CAIRNGORMS NATIONAL PARK AUTHORITY

Title: REPORT ON CALLED-IN PLANNING APPLICATION

DEVELOPMENT PROPOSED: FULL PLANNING PERMISSION FOR ERECTION OF CLUBHOUSE (INCLUDING CHANGE OF USE OF STEADING FOR GOLF BUGGY STORAGE), FORMATION OF CAR PARK AND UPGRADING OF ACCESS, SITE OF PROPOSED GOLF CLUBHOUSE, DALFABER VILLAGE, DALFABER DRIVE, AVIEMORE

REFERENCE: 07/025/CP

Fig. 6. Site plan

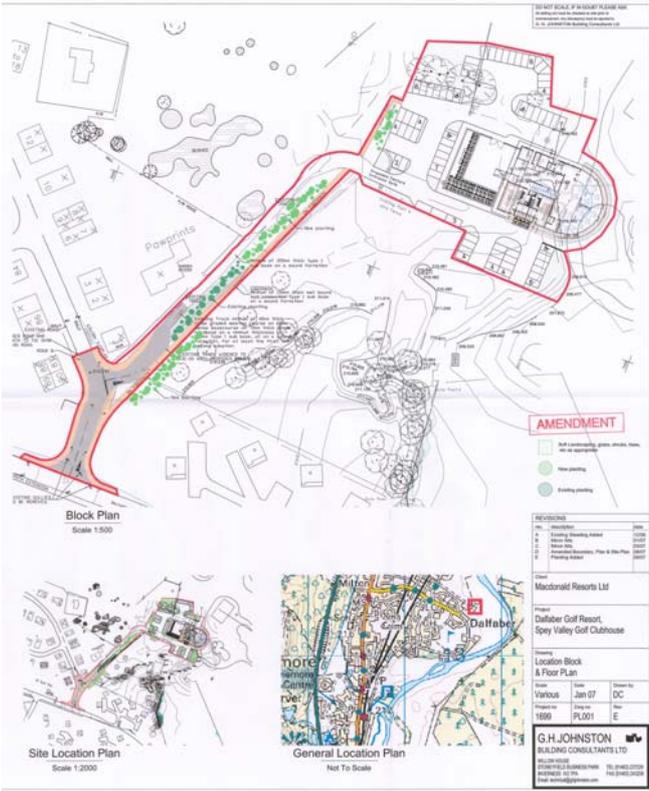
4. Access will be from the existing unsurfaced track leading from Corrou Road. The junctions of Corrou Road and Dalfaber Drive, and Corrou Road and the existing track will be upgraded, and a new 2m wide remote path created along the length of the access to the site. The revisions have amended the arrangement at the new junction of Corrou Road and the track, retaining priority for vehicles on Corrou Road. Parking for 66 cars is proposed in the flat areas surrounding the buildings. Existing trees along the track are shown as being retained and new planting is also indicated in this location.

14. The original plans showed that the access road to the clubhouse was to be single track in places. This raised concerns with the **Outdoor Access Officer** about provision and safety of non-motorised approaches and the separation of vehicles and people on the road. Taking all this on board, it was therefore recommended that; non-vehicular access must be catered for along the access road to the car park with particular regard to where the road narrows to single track. This should be to all-abilities standards e.g. wide enough to accommodate wheelchairs and with drop kerbs if necessary; a separate access into the car park for recreational users beyond the vehicle entrance gate (between the 4-bay and 6-bay parking spaces which is the same location as the current access), in the form of either a gap preferably, or a gate. If a gate is installed it must be unlocked at all times and present no barriers to a wide range of users including all-abilities and should comply with the BT Countryside for All Standards and Guidelines; if perimeter fencing is used where the access route emerges onto the course, a further gap or gate must be installed to the same standard as above; clear and welcoming waymarking must be in place from the turnoff at Dalfaber Drive to where the access route crosses the course, directing recreational users to the river. This waymarking must be compliant with the Scottish Outdoor Access Code.

15. Following the revisions, the **Outdoor Access Officer** states that she supports the changes and the establishment of the 2m wide remote path. It would be preferable to have a gap into the proposed car park rather than a gate as shown. However, if a gate remains, it should be 2m wide, self-closing and accessible for all-abilities, including wheelchairs. It should not feature any kind of extra barrier such as a kissing gate or chicane.

7. That the 2m wide path on the south east side of the access road and extending into the site, shall be constructed to all abilities standards (BT Countryside for All) and shall be completed and available for use, prior to the occupation of the clubhouse hereby approved.

8. That on completion of the development hereby approved, and unless otherwise agreed in writing with the CNPA acting as Planning Authority, uninterrupted public access through the site shall be maintained at all times in the future. For the avoidance of doubt, any gates installed shall be self-closing, be a minimum of 2m in width and shall remain unlocked at all times.

Fig. 8. Extant Permission Design

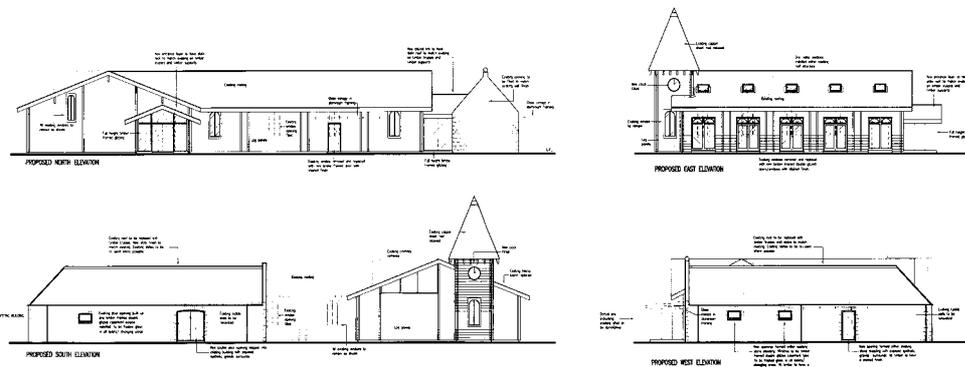
30. The starting point though is the design of the building approved under the existing permission. This comprises a pitched roof timber clad structure with a clock tower. It was in fact the former "Santa Claus" building from the Aviemore Resort which was to be relocated. This permission remains extant and could be implemented at any time up until April 2009. It is not known though if this structure still exists. Nevertheless, the new design must be seen in the context of this existing permission.

31. It is the case that the new building is clearly different in appearance and character to that of the existing steading, and the initial submission showed the new building physically adjoining the steading. This accentuated the difference in character and appearance between the existing and the proposed buildings. Following negotiations some amendments have been submitted. These include detaching the two buildings; the introduction of rooflights; use of some timber cladding and adding additional fenestration to the side elevations; removal of the understorey stone wall supporting the projecting south eastern end and replacement with structural columns; and the introduction of overhanging planting on the decking area. In my view, the revisions have resulted in improvements. Separating the buildings, allows the retention of the individual identity and character of both the existing and proposed buildings. Removing the "heavy" understorey wall and creating overhanging planting "lightens, raises and softens" the appearance of the projecting curved glazed feature, and the additional fenestration adds more interest and breaks up the scale of the elevations and roof.

32. It is understandable that some concern has been raised about the design because of the difference in character and appearance. However, I take the view that the revised design is acceptable in this instance. In design terms, golf clubhouse buildings often act as a focus and a feature in a landscape. I do not find that the scale is excessive. It is certainly different in character and appearance to the existing steading but its profile and height is low. I would argue that the existing approved clubhouse design is also very much different in character and appearance to the steading and its immediate surroundings, and indeed it is higher in profile. As good designs should, the new building takes advantage of the open aspect and sloping ground towards the golf course and the river. Indeed, the concept is to provide its main relationship with the golf course it serves. The use of reclaimed stone is certainly welcomed but I have no objection to the more contemporary approach employed here.
